寄件者: Ping Yeung <[REDACTED]>
寄件日期: 2026年07月29日星期三 8:55
收件者: Adrian Tsz Hin TAM/PLAND
主旨: Re: Planning Application No. A/NE-TKL/841 --- Temporary Private Vehicle Park (Private Cars Only) for a Period of 3 Years
附件: Swept path analysis for car park at DD79 Lot 1057 6.pdf
類別: Internet Email

Swept path analysis for car park at DD79 Lot 1057

Swept path "In" for parking space No. 25,26,27

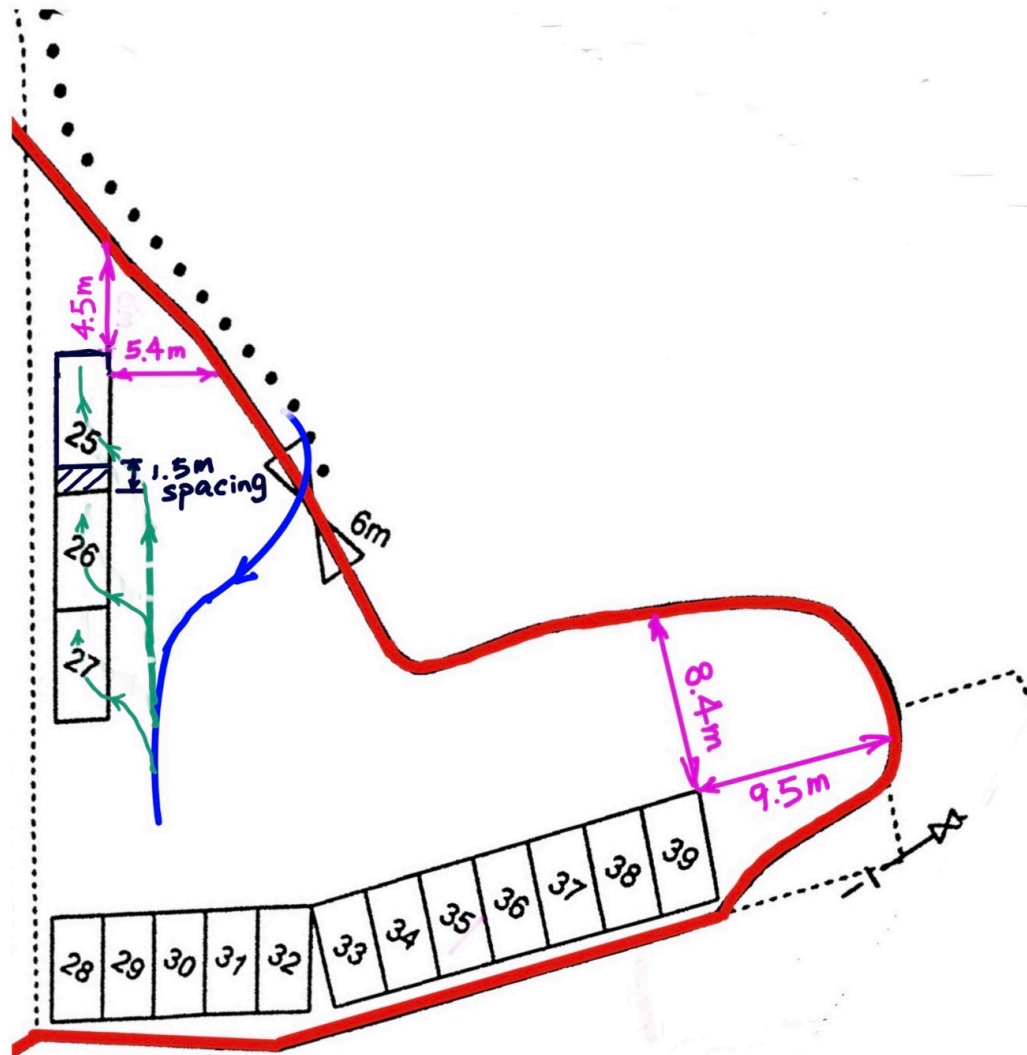
- i. 申請地點離開坪原路都有一段路，應不會影響路面上的交通往來，我們另設一些速度指示牌 (5km/hr)。
- ii. 補充了一些圖，解釋 25, 26 號車位的駕駛人士可以容易進出，見以上附件。
- iii. 將設有「前面路上有行人或有行人橫過」的標誌。
- iv. 由於車位是供給我們村民使用，我們將車位設定為固定車位，不會對外開放給外來人停泊。
- v. 根據《道路交通條例》所有車輛必須持有有效的行車證，方可停泊此停車場。
- vi. 由於固定車位，所以應不會出現車輛排隊現象。
